NEW BRITAIN TOWNSHIP

SUBDIVISION & LAND DEVELOPMENT APPLICATION

4. Name of Subdivision or Land Development: Gilmore Subdivision & Land Preservation

TYPICAL FRONT VIEW OF NON-VEGETATED MRC BASIN

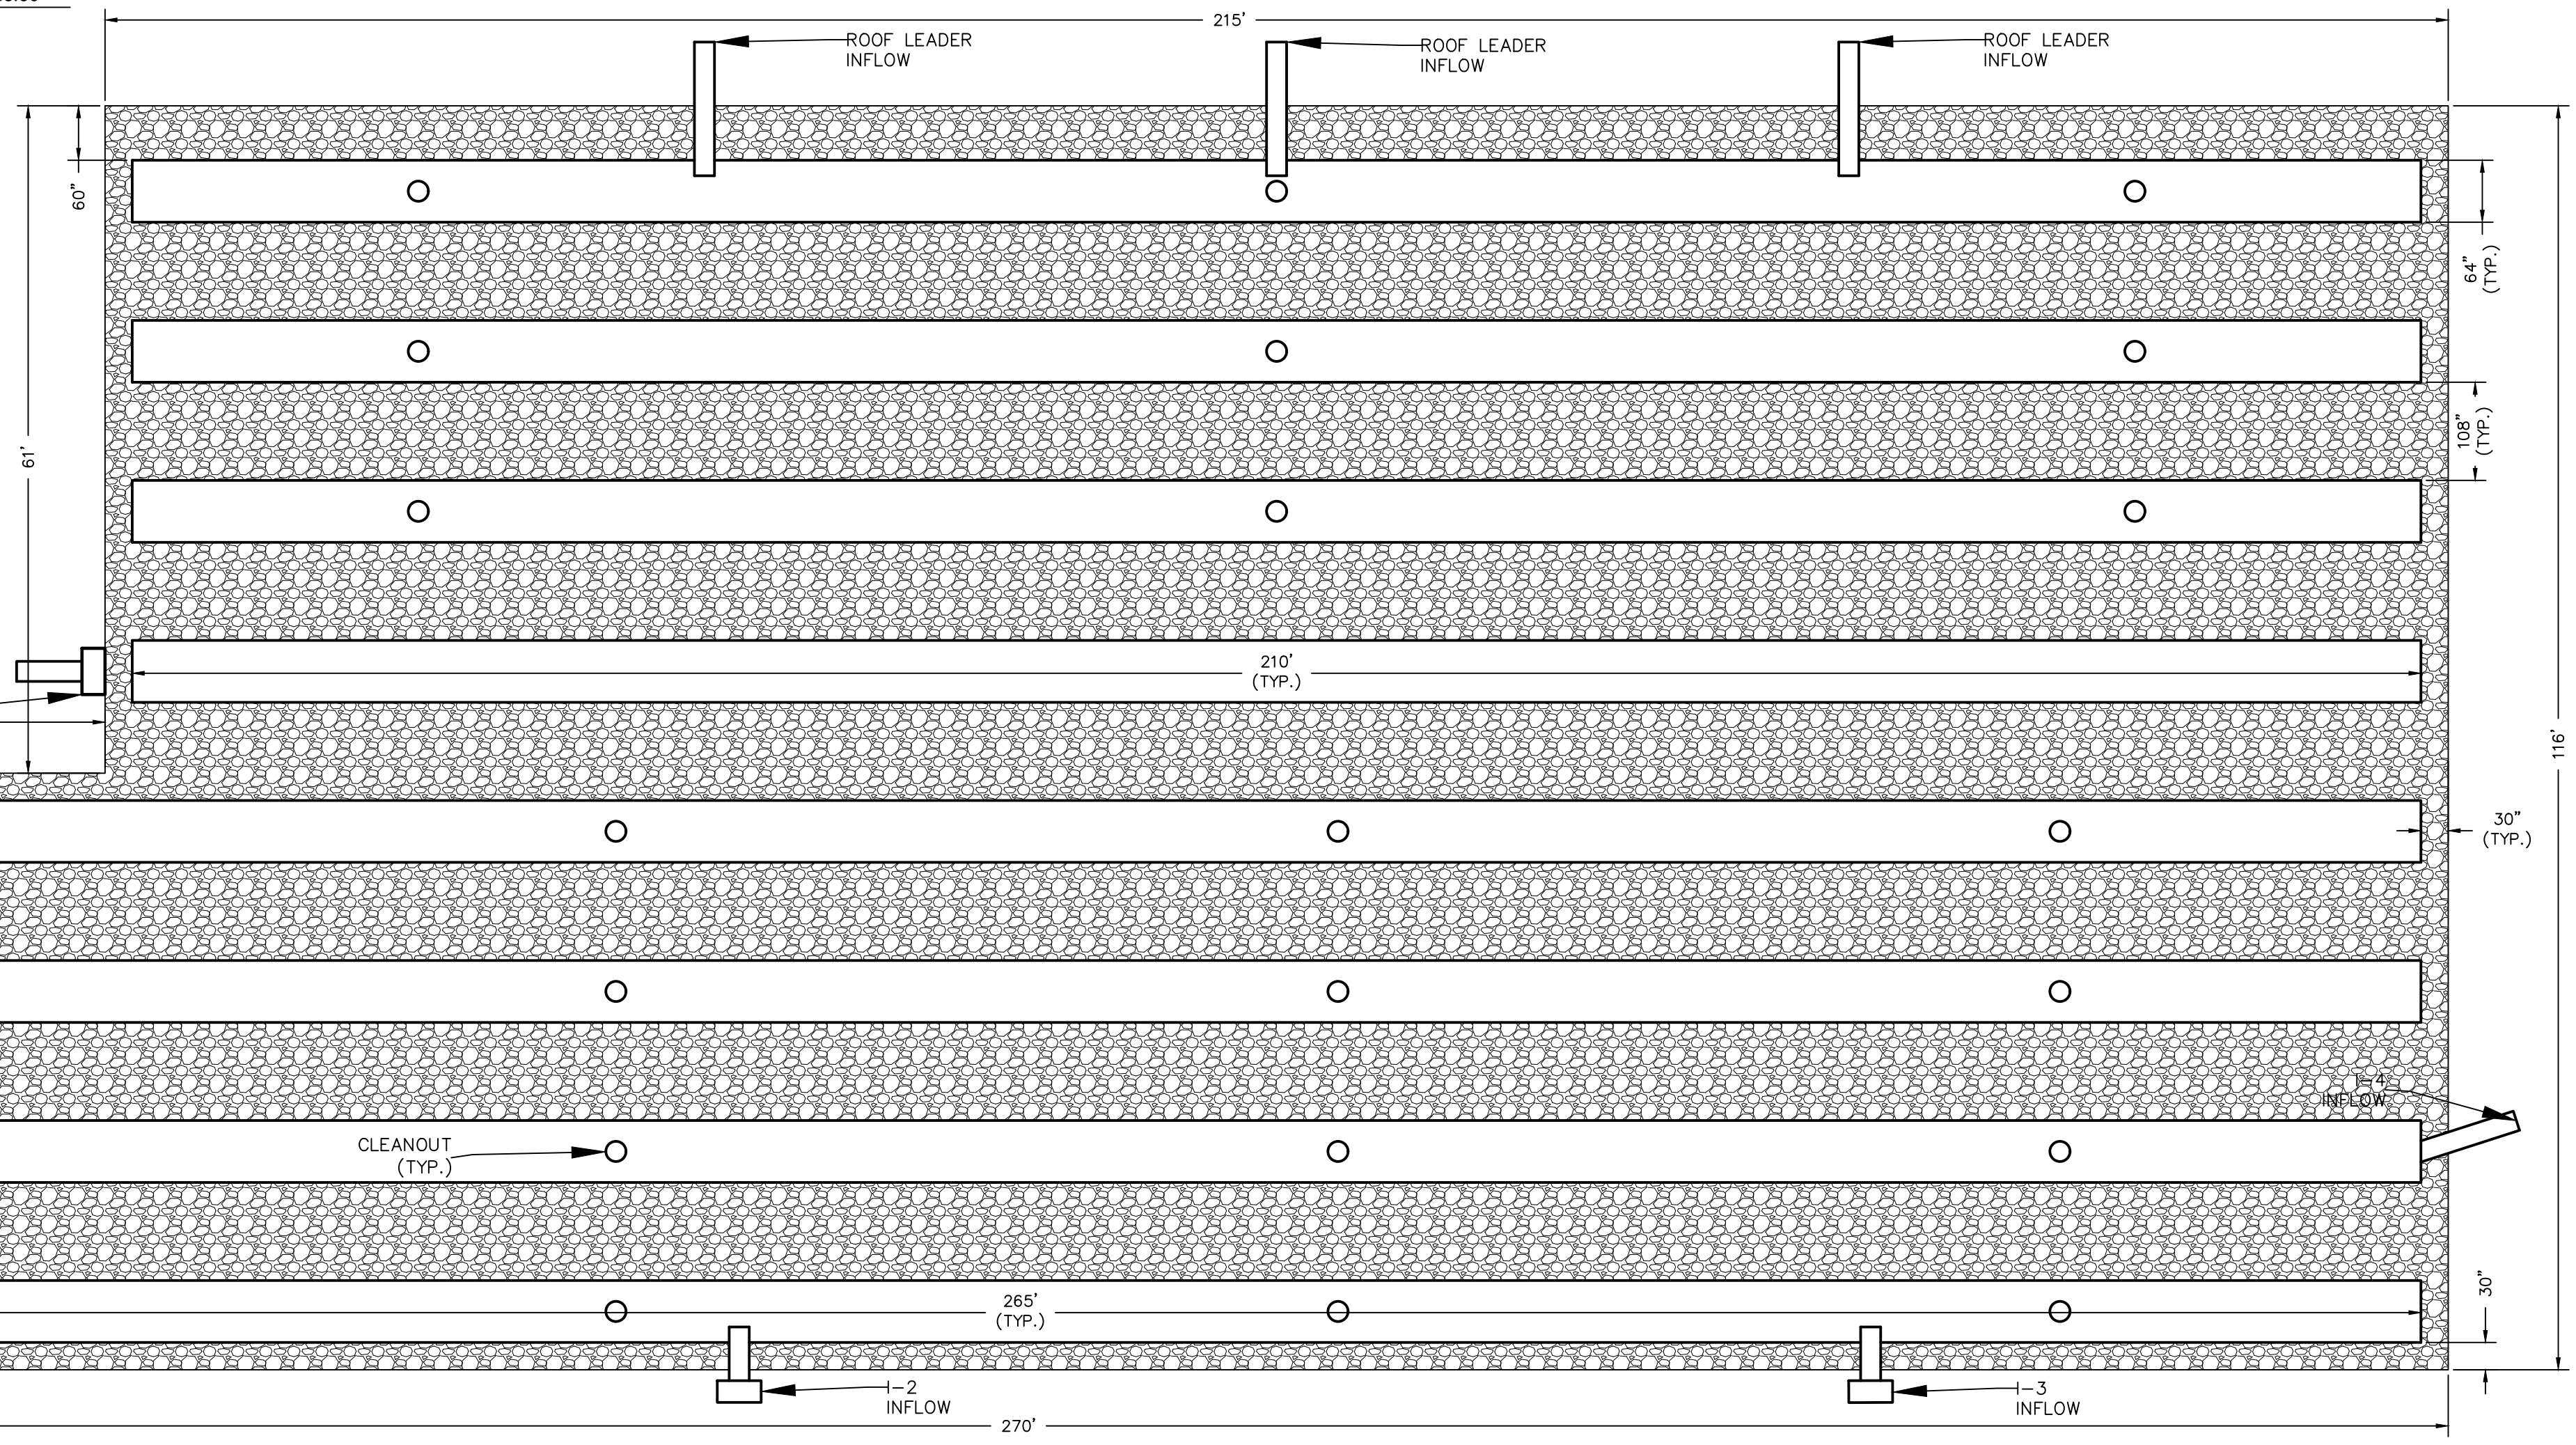
10. §26-132 – The following discrepancies with the stormwater management design and plans shall be addressed:
 - a. The Typical Front View of Non-Vegetated MRC Basin detail on Sheet 13 does not appear to include the stone over the chambers modeled in the stormwater report. Based on the report, 6 inches of stone should be specified over MRC Basin 1 and 30 inches of stone over MRC Basin 2. The detail and report shall be revised as necessary to clarify the extent of the stone envelope.

- b. The elevations of the 3-inch orifice and 18-inch outlet pipe for MRC Basin 2 modeled in the stormwater report shall be verified and coordinated with the elevations provided in the Typical Front View of Non-Vegetated MRC Basin detail on Sheet 13.

- c. The 36"x12" bypass orifice at an elevation of 295.00 for MRC Basin 1 shall be verified and coordinated with the details on Sheet 13 that note an elevation of 294.50.

- d. The slope of the pipe from Inlet I-4 shall be revised to match the chamber elevation of 283.50 in MRC Basin 2.
 - e. The Overview of Non-Vegetated MRC Basin 2 detail on Sheet 13 shows 3 roof drain connections, while the Utility Plan shows two connections. In addition, the Utility Plan shows two roof drain connections to MRC Basin 1 which are not shown on the detail. The details shall be revised as necessary to be consistent with the plans.

- i. The location and number of underdrain pipes and the 10" PVC lateral pipes between chambers shall be shown on the overview layout detail on Sheet 13.
